IMPROVEMENT ON PRODUCTS	<b>All low lube fifth wheels</b>
NEW PART NUMBER	<b>RR00279</b>

NEW PART NUMBER*	<b>RR00279</b>
IN PRODUCTION FROM	<b>September 2015</b>

NEW PART NR. RR00279

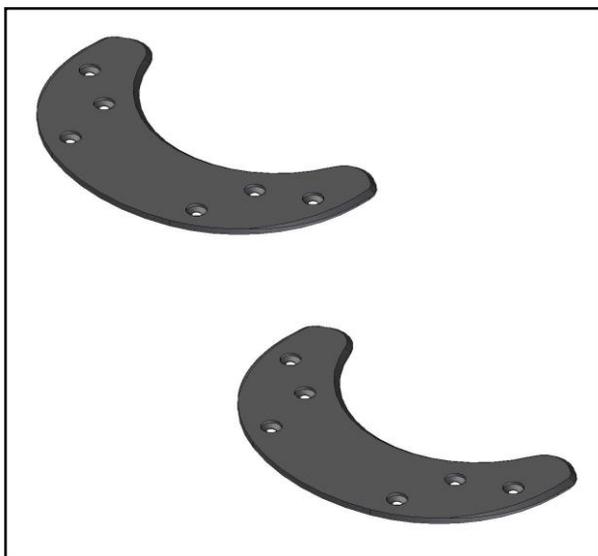
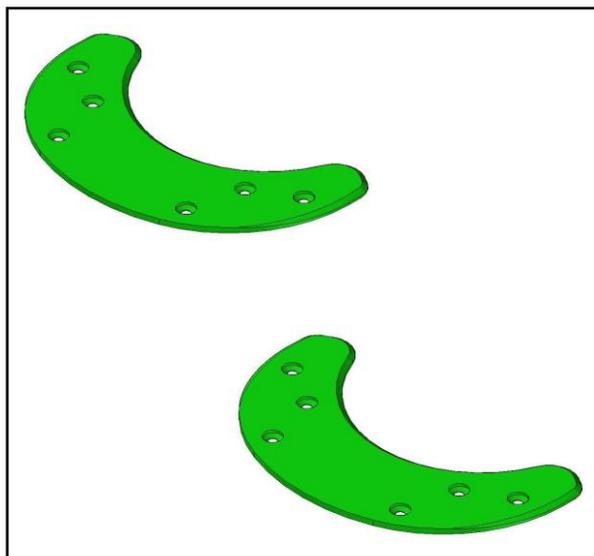
1. It can be retrofitted on any low lube fifth wheel (RP50-T, RP10-P, RP10-S, RP10-K, ...)
2. The low lube inserts belong to a flat rolled plate; the previous green low lube inserts RR00081 belong to an injection molded. This means a longest lasting time and a better performance of the new material.
3. The new kit RR00279 is now black colored; the previous RR00081 was green colored. This means that it will be easy to identify it.
4. The new kit RR00279 will become a standard for all markets
